S.I. M20-55

SUBJECT: Instrument Panel and Glareshield Lights, Light Control Rheostat Wiring Modification.

**MODELS/
SERIAL NUMBERS
AFFECTED:** Mooney Models M20J, S/N 24-0927 through 24-1085, M20K, S/N 25-0280 through 25-0542.

Figure A

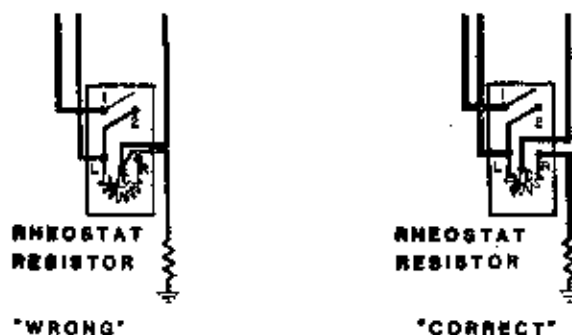
INTRODUCTION: An error in the subject light control rheostat wiring will cause excessive current to be drawn through the rheostat and bias resistor when the lights are turned up toward the "BRIGHT" end of the control. This can result in shortened life of these components due to heat. It is recommended that the wiring connection between the resistor and the rheostat be inspected and changed per the following diagrams if necessary.

INSTRUCTIONS: Look under instrument panel, with appropriate light source, to determine if wiring between resistors and rheostats is properly connected. The wire from the resistor should be connected to the "R" terminal on the rheostat. Some have been found connected to the "C" terminal which causes the condition described above. See Figure "A" for proper connections.

If improperly wired, move resistor wire connection from "C" (wiper) to "R" terminal on rheostat when viewed from switch end with terminals pointed down. See Figure "B" for clarification.
